STATE OF NORTH CAROLINA
DEPARTMENT OF TRANSPORTATION

Addendum No. 1
RE: Contract # C204039
WBS # 34243.3.2
STATE FUNDED
Polk County (I-4729A)
I-26/US-74/NC-108 Interchange Modifications in the Town Of Columbus

September 19, 2017 Letting

The following revisions have been made to the Roadway plans:

0 5 10
PROJ. REFERENCE NO.
I-4729A
SHEET NO.
X-67
6/23/16
℄ -RP-WC-
SP 133
RETAINING WALL NO. 58
1062.27
40+85.47
℄ -RP-WC-
SP 134
RETAINING WALL NO. 58
0.049
0.049
1061.60
40+50.00
-W_CONN_REV-
4-AUG-2017 08:20
J:\I-4729A\Roadway\XSC\I-4729A_Rdy_xpl.dgn
$$$$USERNAME$$$$

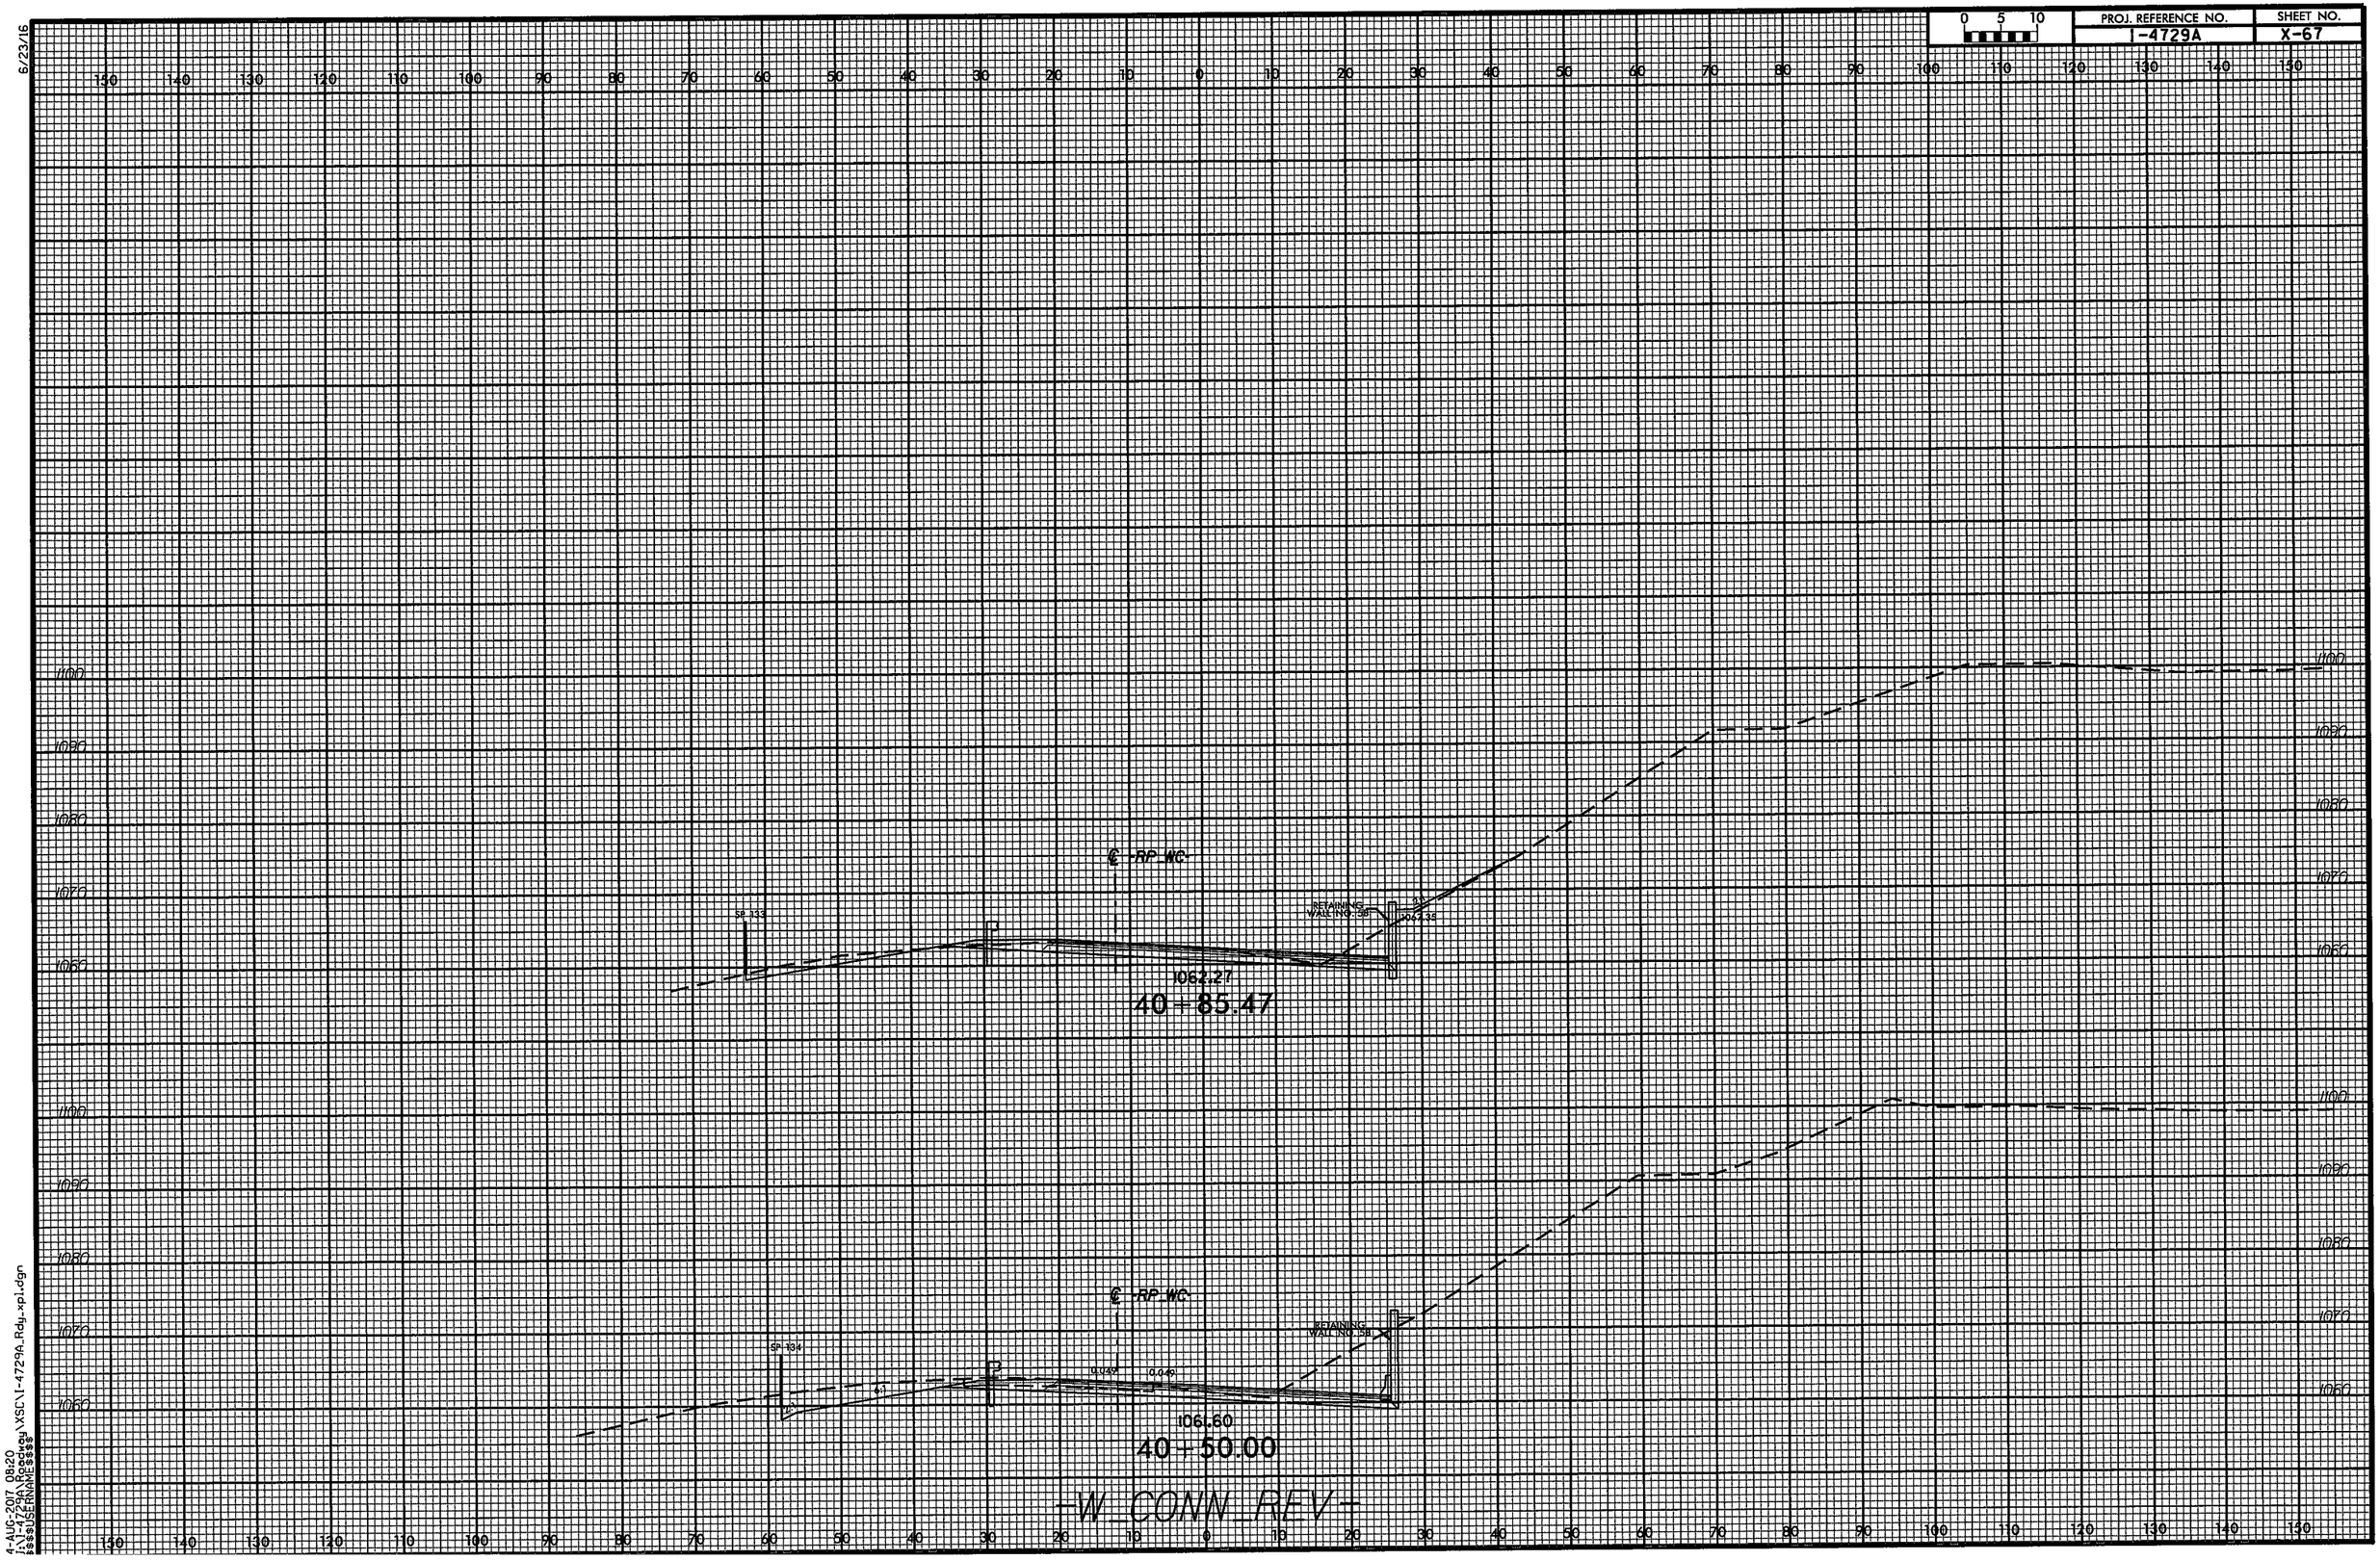
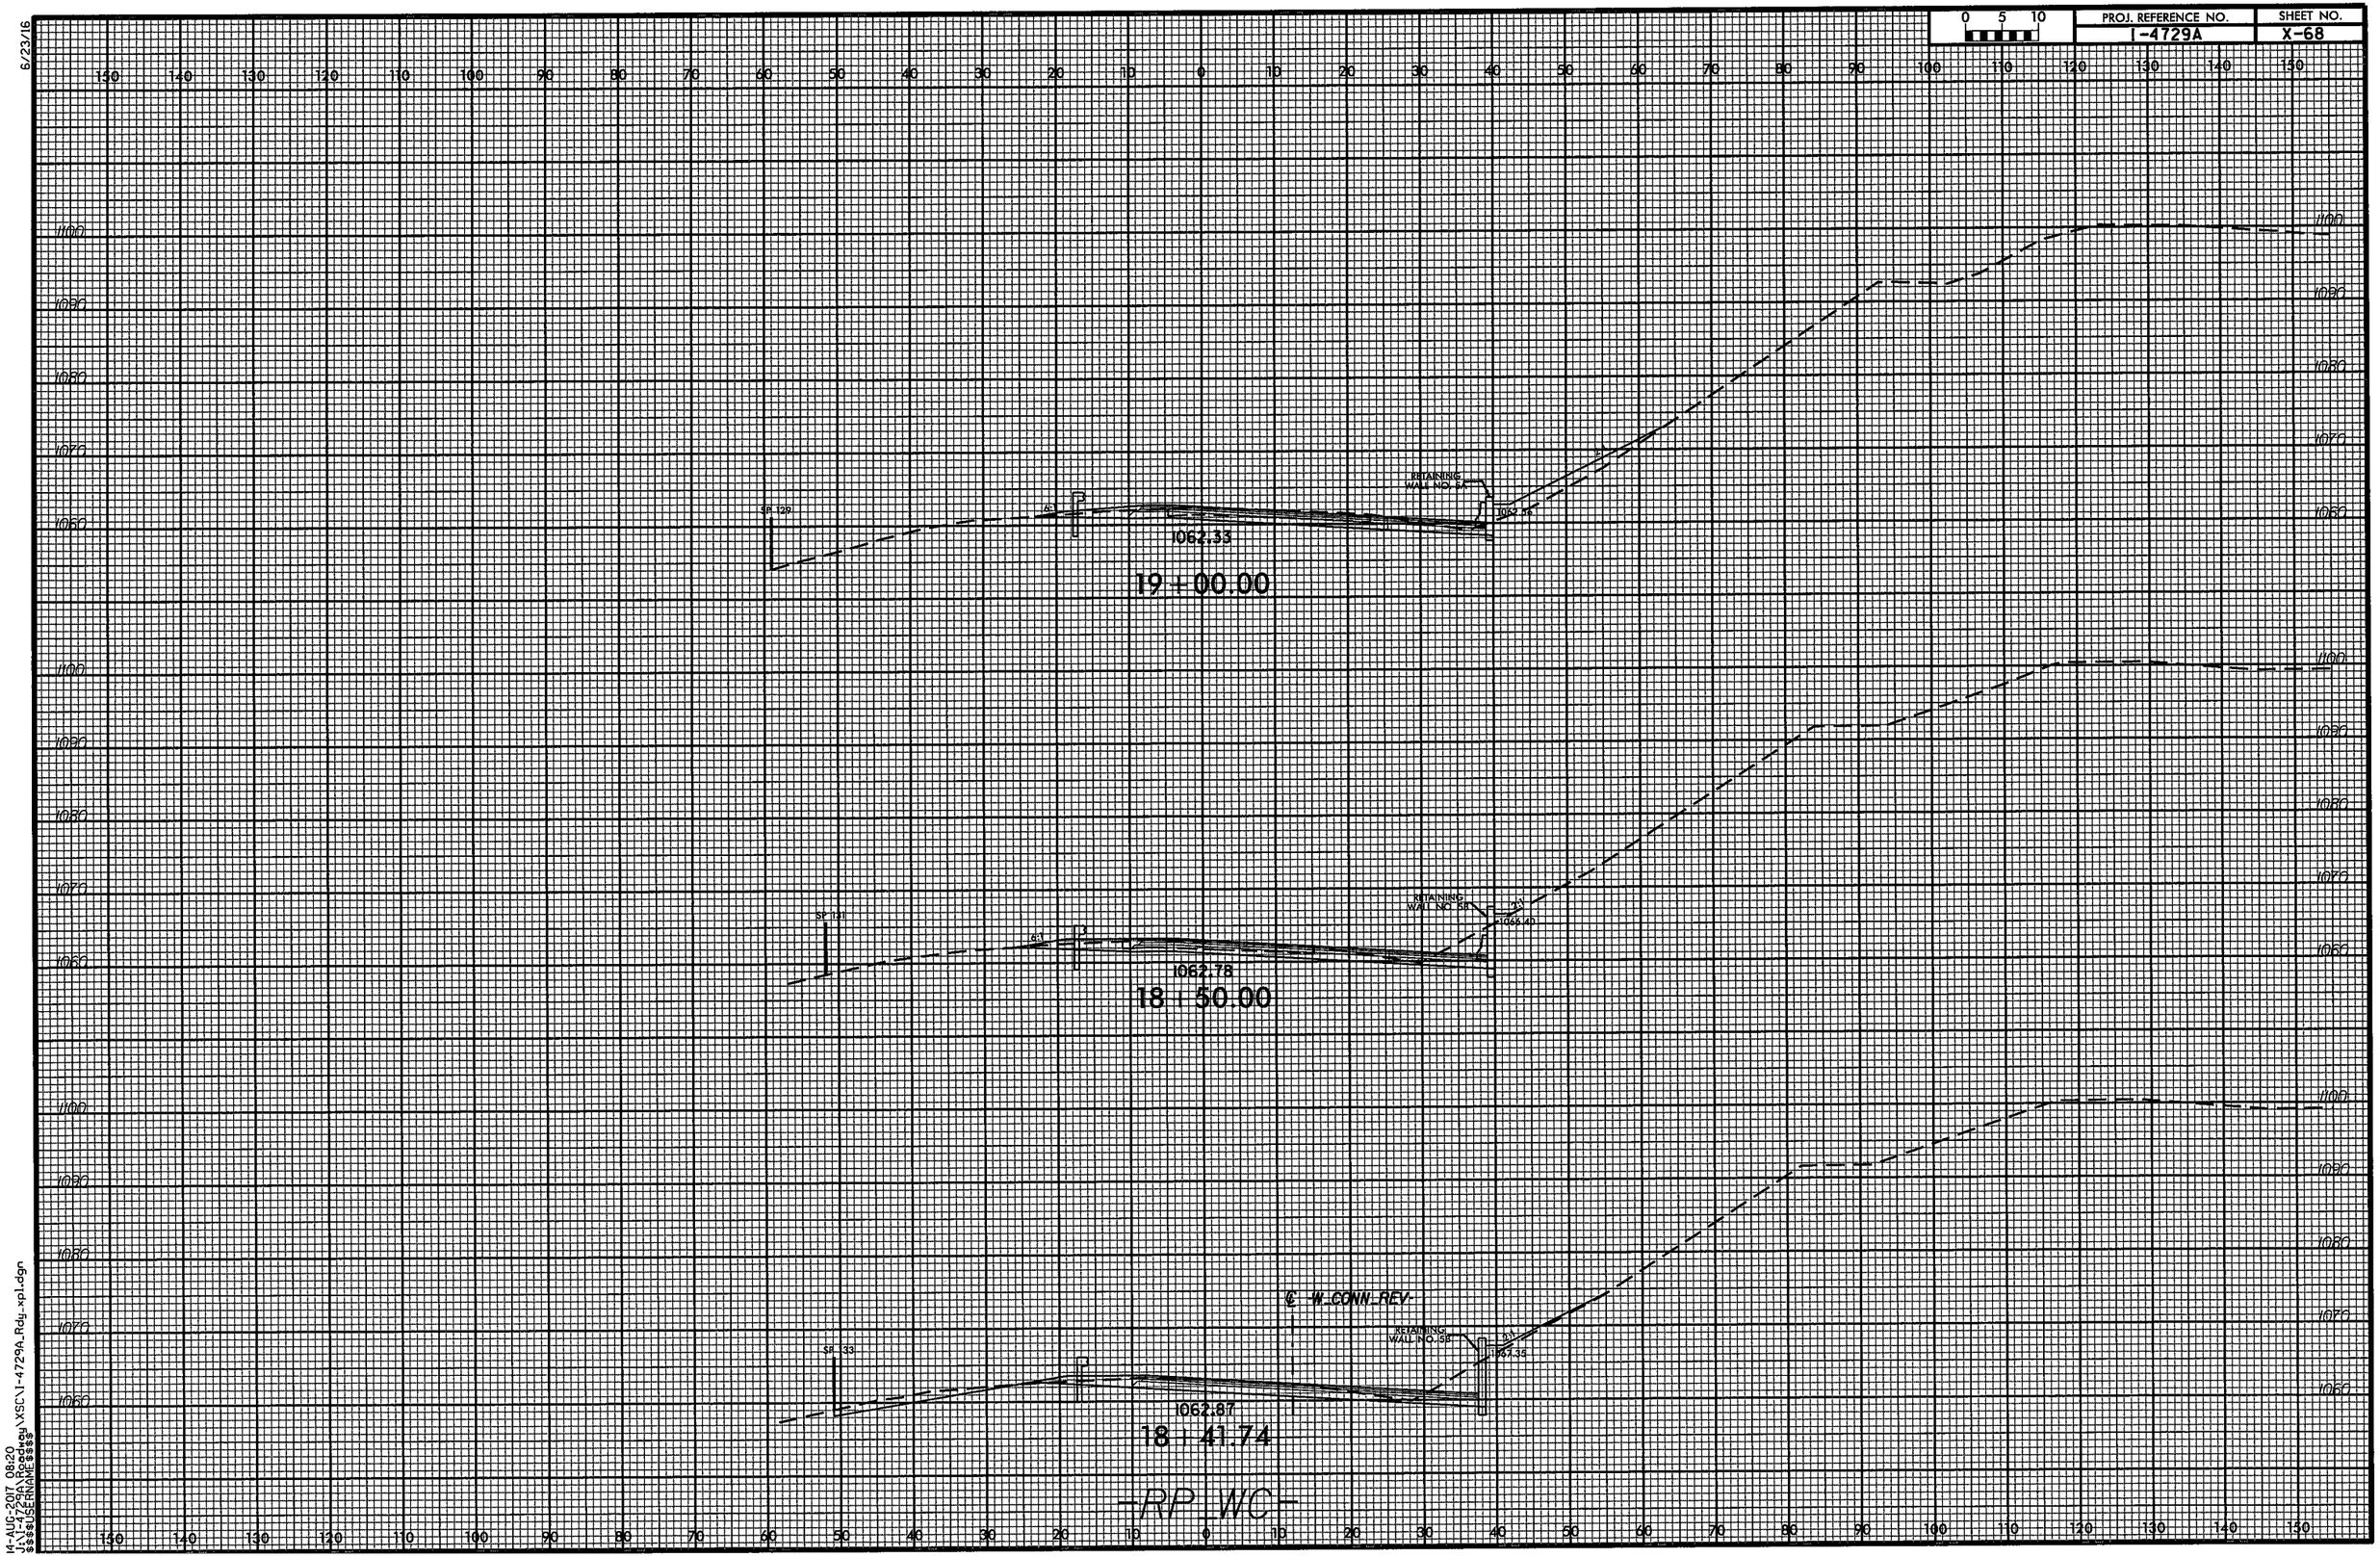
Sheet No.	Revisions
1A	Revised Index of Sheets to remove 2G-2 "Standard Embankment Monitoring Detail" and revise the number of" Drainage Summaries" sheets
2A-1, 2A-4 and 2A-5	Revised the Typical Sections for the change in mainline pavement widening design from ABC to Asphalt Base
3B-1	Revised 'Summary of Earthwork' to account for pavement widening design change
3D-1 thru 3D-4	Various drainage quantity changes as noted below
3G-1	Removed "Settlement Gauge Summary" and added note that Bridge Waiting Period only applies to Approach Slab construction
5	Revised to require Welded Steel Pipe by Trenchless method under the Interstate 26
X-1A thru X-87	Revised Cross-Sections to reflect the change in Earthwork due to the pavement design change
